Company	Trenz Electronic GmbH
PCN Number	PCN-202008187
Title	KK0803-03 to KK0803-03A Hardware Revision Change
Subject	Hardware Revision Change
Issue Date	2020-10-02

2.1 #1 Added four M3 mountig holes.

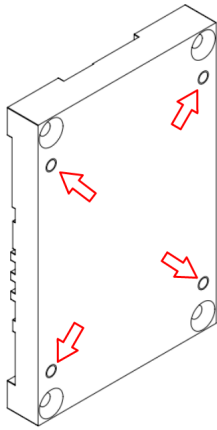
Type: Hardware change

Reason: Request for screwed mounting of cooler on heatspreader.

Impact: The heatspreader is compatible with cooler KK0001-01.
